COMMUNITY DEVELOPMENT DEPARTMENT

January 2, 2025

**Re: Development Review Permit, Heritage Tree Removal Permit, and Vesting Tentative Map
1919-1933 Gamel Way, 574 Escuela Avenue & 1970 Latham (APN: 154-21-007 thru 011 and 154-21-013)
PL-2023-154 & PL-2023-155**

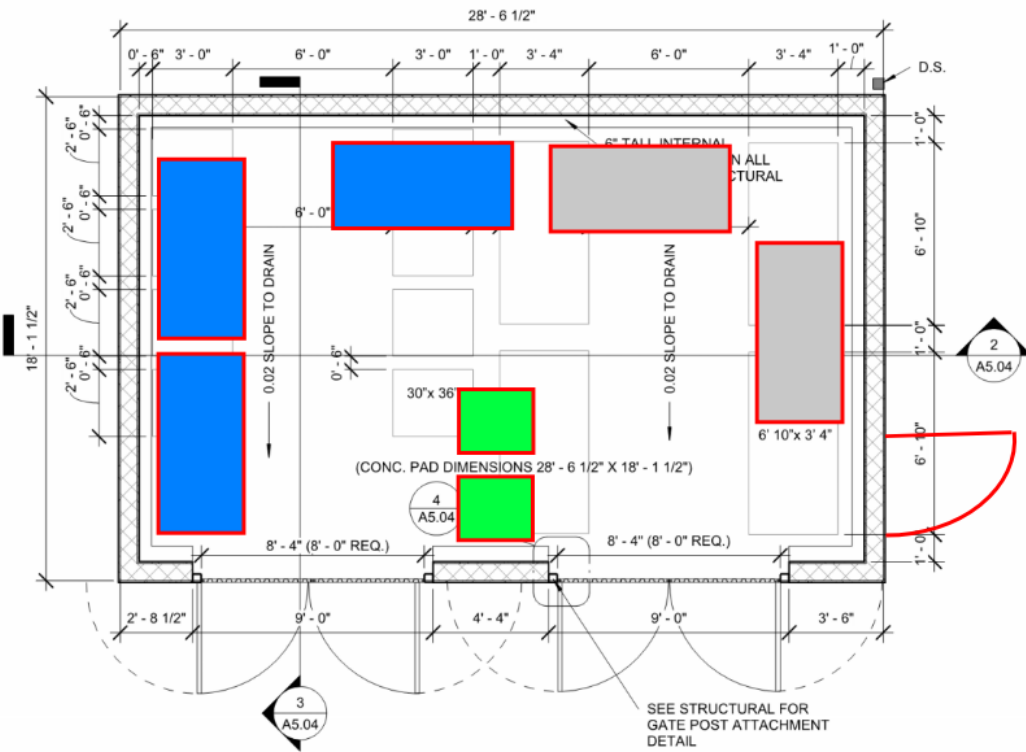
<p>1970 Latham Ave Sheet T0.0 – 1970 Latham Enclosure Design</p> <ul style="list-style-type: none"> ○ Label the sheet as trash enclosure for 1970 Latham so it is clear what site the trash enclosure is for. ○ Reduce the almost 3’ gap between the CMU walls and the metal enclosure roof. Large gaps like this can encourage people to throw their bags of waste over the top of the wall instead of walking into the enclosure and putting trash bags directly in the collection containers. ○ Provide a pedestrian door for residents to access the trash room. To fit the collection containers with a pedestrian door, please see the attached example layout. The number of trash bins can be reduced to 2 – 3yd bins and 1 – 3yd bin for paper

and 1 – 2yd bin for container recycling (optional fifth bin for cardboard only or extra trash bin). Please note, 2 – 64 gal compost cart are need and have been added to the trash room in the example layout.
